Revisions to Operator-Submitted EC Data for Sundry Notice #448615

Revised Permit Information 12/18/18:

Well Name: Green Drake 16 Fed Com No. 704H

PECOS DISTRICT DRILLING CONDITIONS OF APPROVAL

**Proposed Wellbore
Revised 12/18/18
API: 30-025-*******

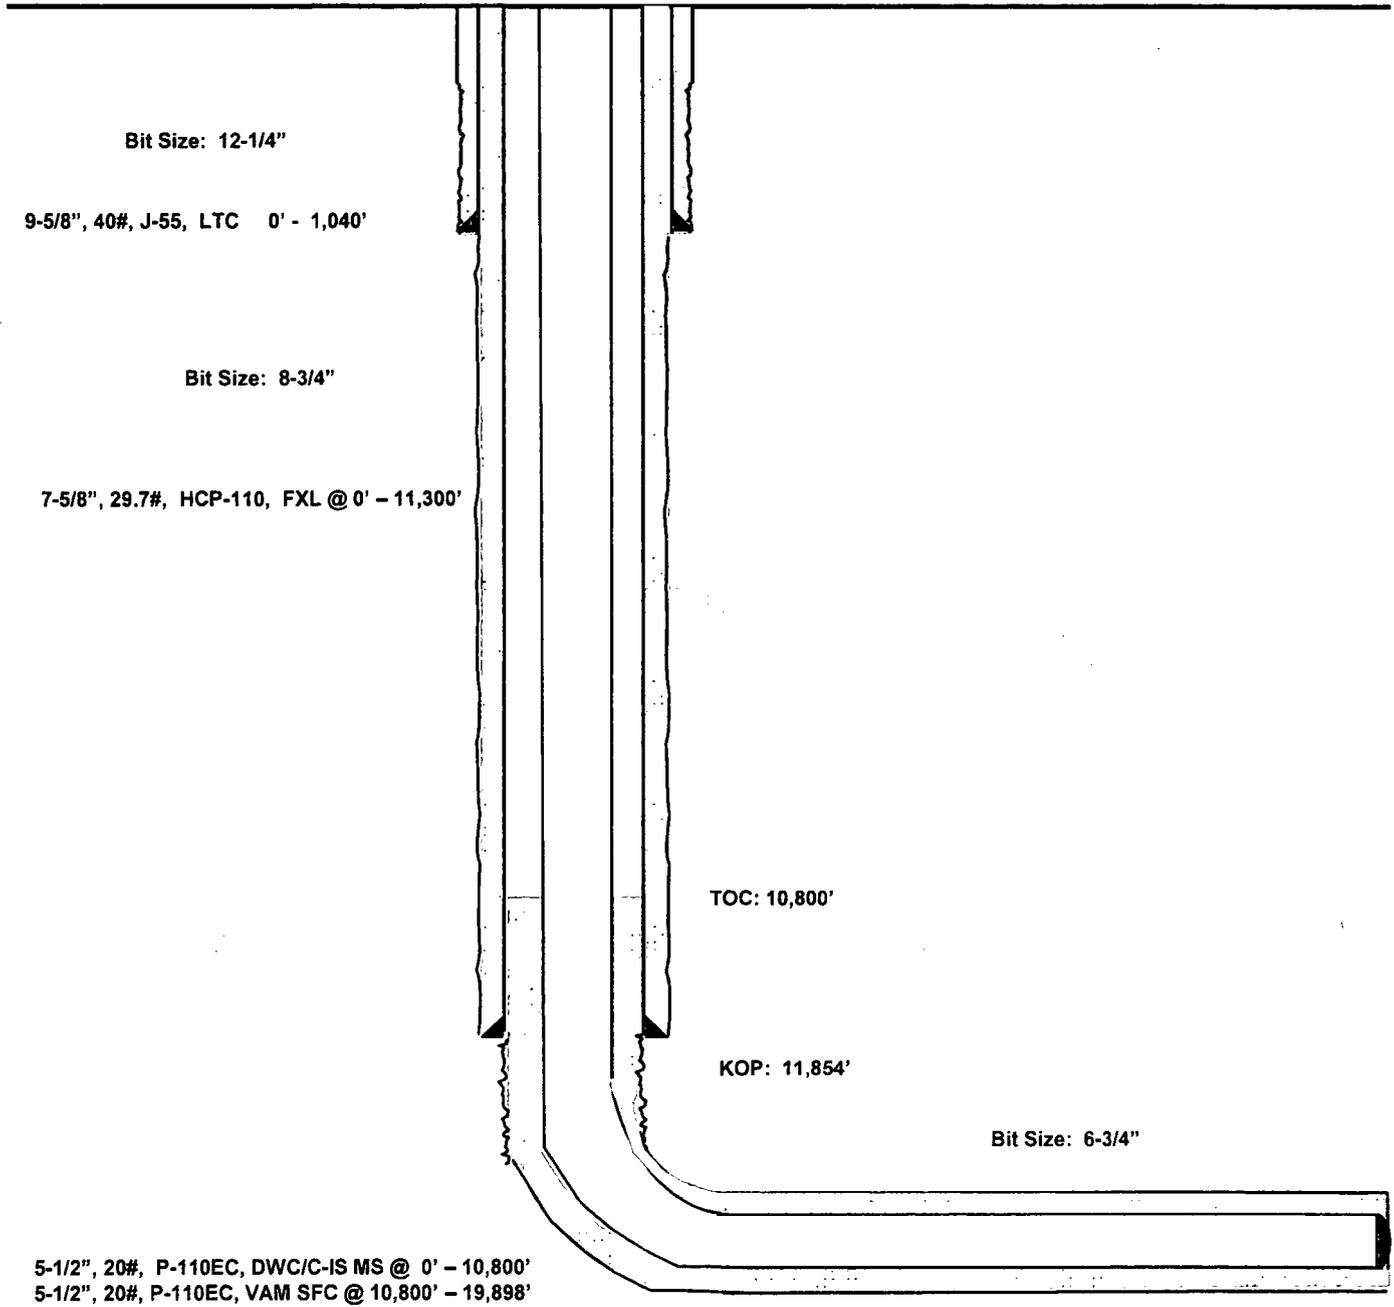
Hole Size	Interval	Csg OD	Weight	Grade	Conn	DF _{min} Collapse	DF _{min} Burst	DF _{min} Tension
12.25"	0 – 1,040'	9.625"	40#	J55	LTC	1.125	1.25	1.60
8.75"	0 – 11,300'	7.625"	29.7#	HCP-110	FXL	1.125	1.25	1.60
6.75"	0' – 10,800'	5.5"	20#	P-110EC	DWC/C-IS MS	1.125	1.25	1.60
6.75"	10,800'-19.898'	5.5"	20#	P-110EC	VAM SFC	1.125	1.25	1.60

Variance is requested to waive the centralizer requirements for the 7-5/8" FJ casing in the 8-3/4" hole size. An expansion additive will be utilized, in the cement slurry, for the entire length of the 8-3/4" hole interval to maximize cement bond and zonal isolation.

Variance is also requested to waive any centralizer requirements for the 5-1/2" FJ casing in the 6-3/4" hole size. An expansion additive will be utilized, in the cement slurry, for the entire length of the 6-3/4" hole interval to maximize cement bond and zonal isolation.

Depth	No. Sacks	Wt. ppg	Yld Ft ³ /ft	Slurry Description
9-5/8" 1,040'	600	13.5	1.73	Lead: Class C + 4.0% Bentonite + 0.6% CD-32 + 0.5% CaCl ₂ + 0.25 lb/sk Cello-Flake (TOC @ Surface)
	200	14.8	1.34	Tail: Class C + 0.6% FL-62 + 0.25 lb/sk Cello-Flake + 0.2% Sodium Metasilicate
7-5/8" 11,300'	390	9.0	3.71	Lead: Class C + 5% Salt + 12% HGS-4K28 + 22% B-52 + 0.15% GXT-C + 0.3% CPT-30 + 0.4% CPT-24 (TOC @ Surface)
	175	11	2.54	Middle: Class C + 3% Salt + 1% PreMag-M + 0.15% GXT-C + 0.15% CPT-30 + 4 pps Blitz + 0.35% CPT-23
	180	14.2	1.11	Tail: Class H + 5% Salt + 0.2% CD-3 + 0.15% CPT-51A + 0.35% CPT-23 + 1% PreMag-M
5-1/2" 19,898'	950	14.1	1.26	Class H + 0.1% C-20 + 0.05% CSA-1000 + 0.20% C-49 + 0.40% C-17 (TOC @ 10,800')

Depth	Type	Weight (ppg)	Viscosity	Water Loss
0 – 1,040'	Fresh - Gel	8.6-8.8	28-34	N/c
1,040' – 11,300'	Oil Base	8.7-9.4	58-68	N/c - 6
11,300' – 19,898' Lateral	Oil Base	10.0-14.0	58-68	3 - 6
